AMENDMENTS AND CLARIFICATIONS TO CURRENT DOCUMENTS

The following documents have been published containing minor errors or ambiguities. These are listed below with the amendment/clarification text. Please note that references to these amendments/clarifications have been noted in the Document Titles and Descriptions section of the catalogue under their relative documents.

Please see image below which is associated with GIRT7016 amendment text above.

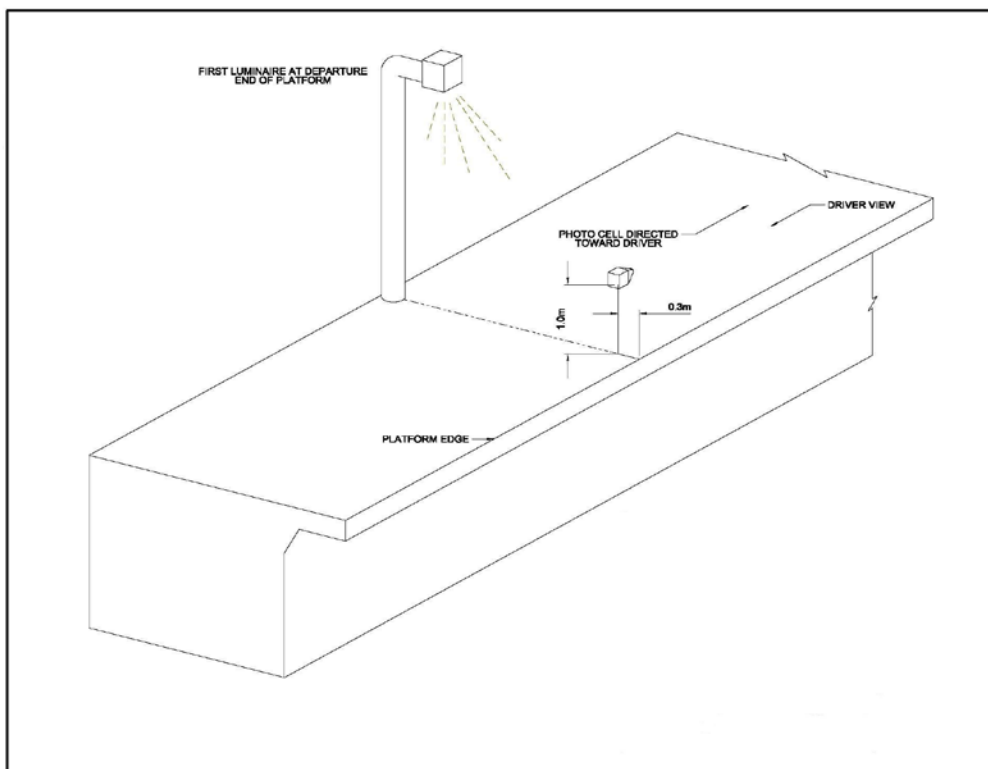
Amendment text Vertical plane illuminance towards an observer viewing parallel to the platform edge

10.3.1 states that:

'There shall be a minimum illuminance of 2 lux measured vertically at a point 1.0 m above the platform surface and perpendicular to the platform edge.'

10.3.2 states that:

'At driver only operation stations (DOO) using mirrors and driver line of sight only, there shall be a minimum illuminance of 6 lux measured vertically at a point of 1.0 m above the platform surface and perpendicular to the platform edge area, along the extent of the platform length to which DOO applies.'

10.3.3 states that:

'The required value shall be achieved at a point of 0.3 m back from the platform edge and opposite the first luminaire on the platform. The measurement point should be directed toward the driver or DOO observation equipment.'

In relation to the above requirements a clarification in the form of a diagram depicting the first luminaire on the platform is provided to illustrate that the higher illuminance values are required where reliance for safe dispatch is by mirrors, and by line of sight only. Where CCTV cameras and monitors are used, the equipment is required to be suitable for operation at the lower illuminance values, and the cameras will be aimed such that screen contrast is not impaired by glare from luminaires.
